City of Richmond
Urban Development Division

Report to Development Permit Panel

To: Development Permit Panel
From: Joe Erceg
Manager, Development Applications
Date: December 12, 2002
File: DP 02-211163
Re: **Application by Fougere Architecture Ltd. for a Development Permit at
9111, 9131 & 9151 Blundell Road and 7731, 7771 & 7831 Heather Street**

SITE PLAN
SCALE 1:500

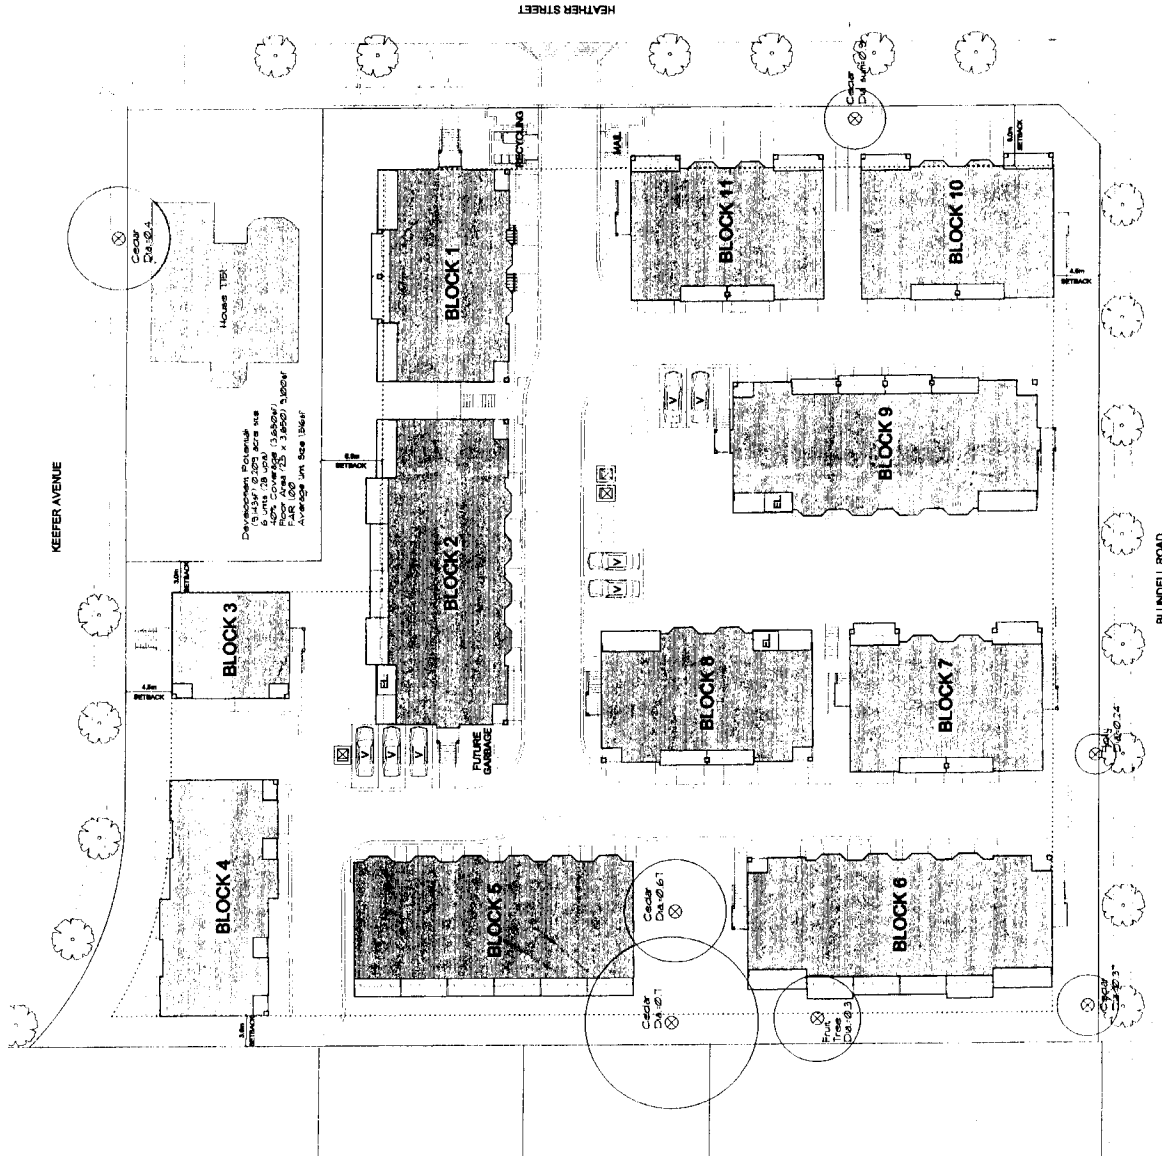
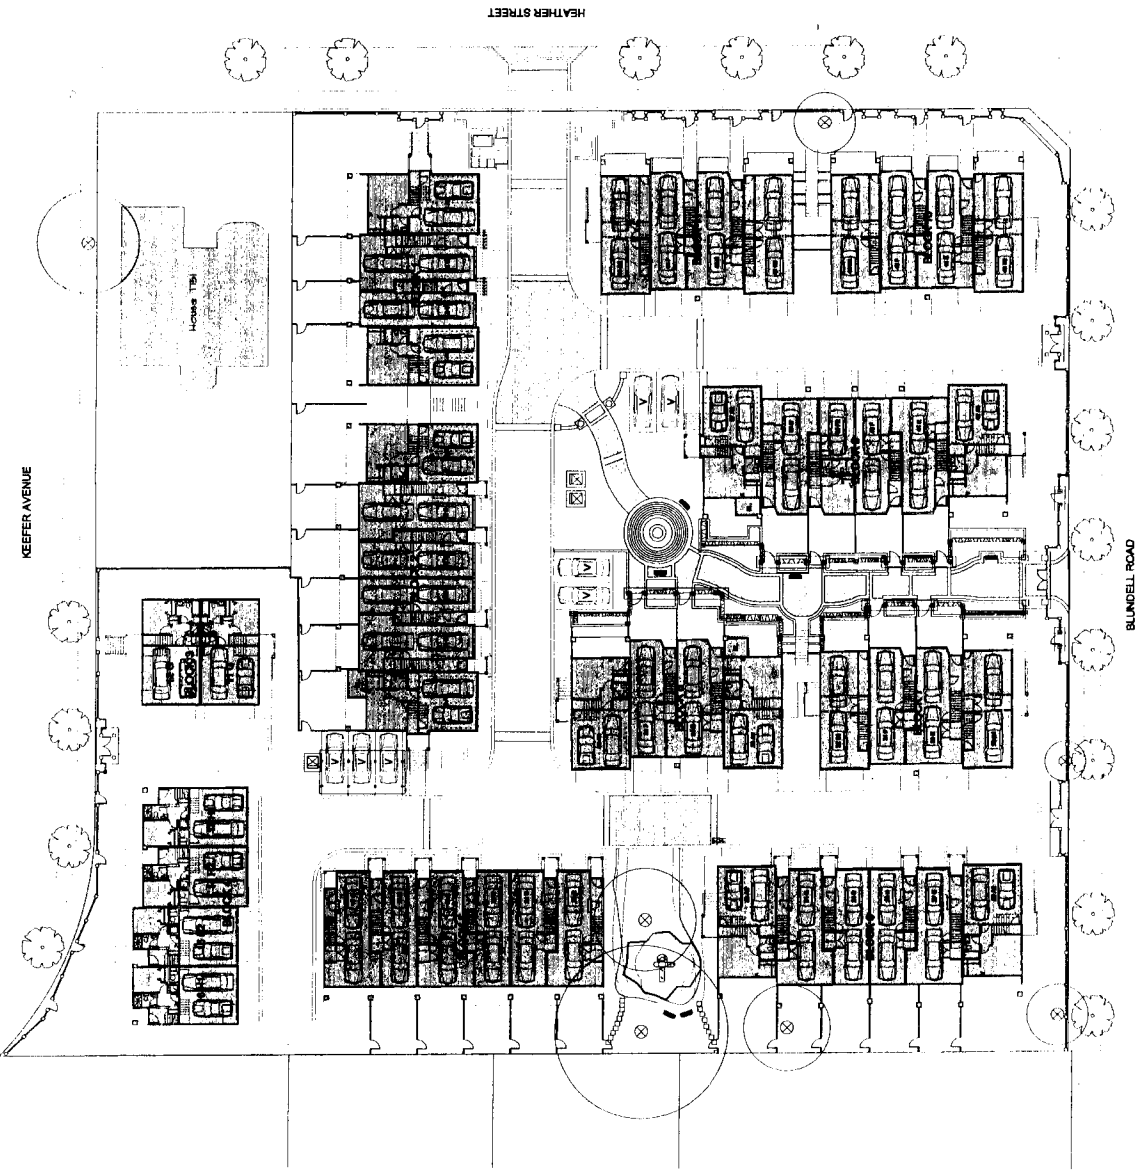
As per Rezoning comments, aisle width minimum 22 ft. (6.7m). Development Permit drawings show only 18 ft.

1. For the very short road sections (the north-south legs shown in the latest site plan), can accept aisle width of 18 ft. (5.5m).
2. However, for the main east-west aisle, this must be 24 ft. (7.3m) as this is the main through-fare on site where there would be more likelihood for two vehicles passing and for fire staging purposes.

(Note: See analysis section for further discussion of the issue of aisle width. The architect has provided a 20 ft. main drive-aisle and 18 ft. secondary aisles.)

There is some discussion of appropriate driveway widths, but there are no guidelines as such. The width is commonly reduced to 20 ft. for townhouse projects of this size and with the concrete aprons, there is adequate room for vehicles to pass and for fire truck staging. (Note: The plans are very similar to the plans presented at the Rezoning stage.)

LANDSCAPE PLAN

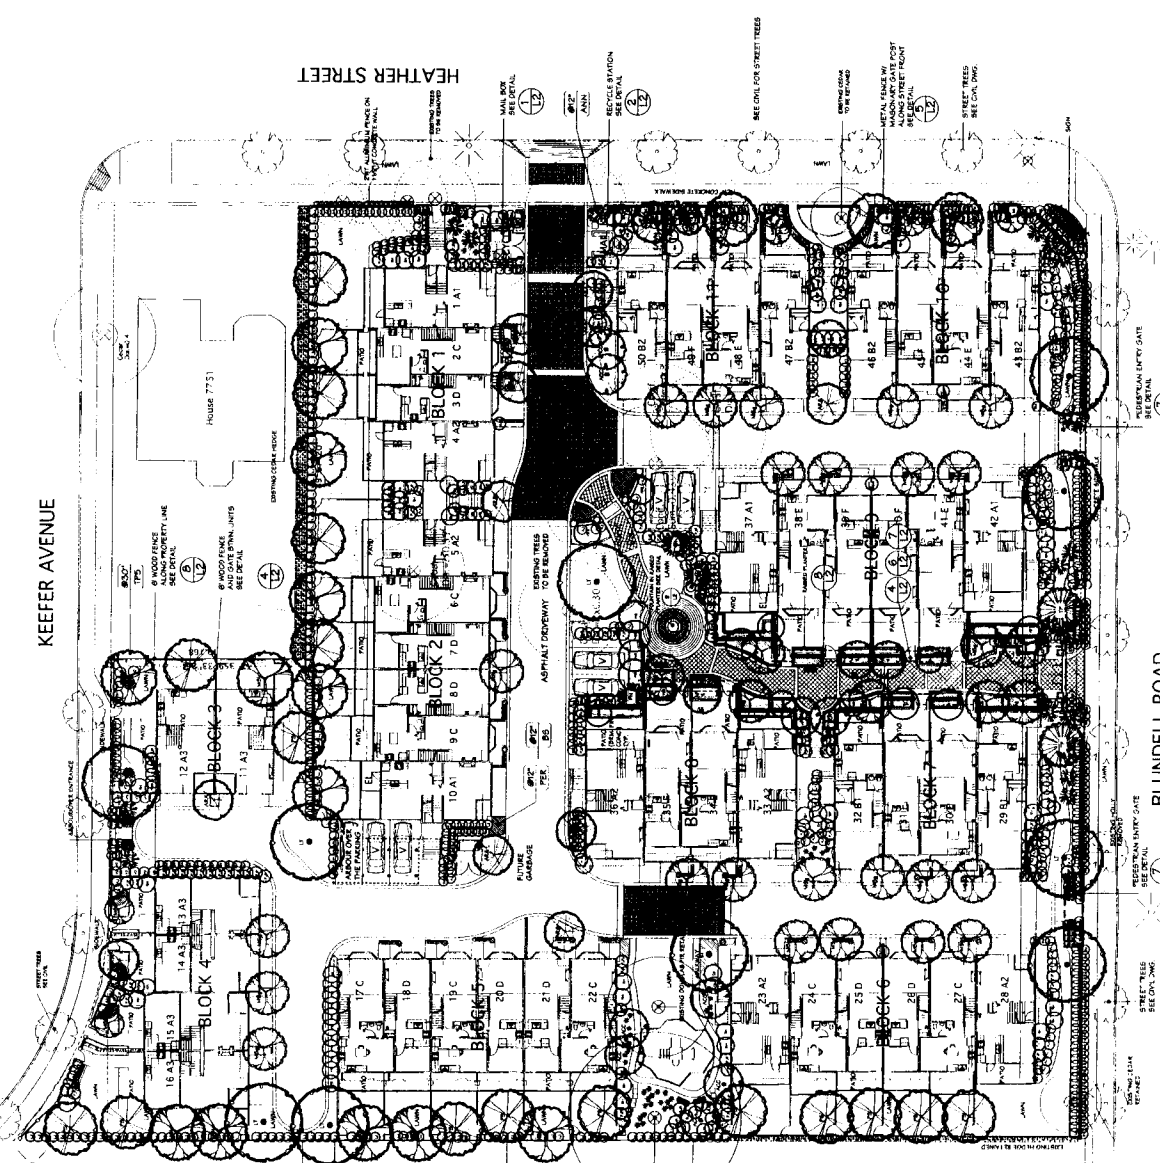
- Setback and landscape between housing types/ neighbourhoods.
- Entry portals, etc. for transition. No vehicle gates.
- Edges between properties to be semi-private but open (no high fences). **The landscape plan shows a six foot fence on the west property line.**

- Co-ordinate contiguous blocks of existing mature trees on adjacent sites. **Contiguous information not provided. The adjacent site is mainly scrub.**
- Encourage privately-owned, publicly accessible open space (POPAS). **None provided.**
- Landscape front yards to enhance the streetscape.

- Enhance or create wildlife habitat using ponds or wetlands with native aquatic and terrestrial plants. **A fountain is provided, but is not a naturalistic design.**
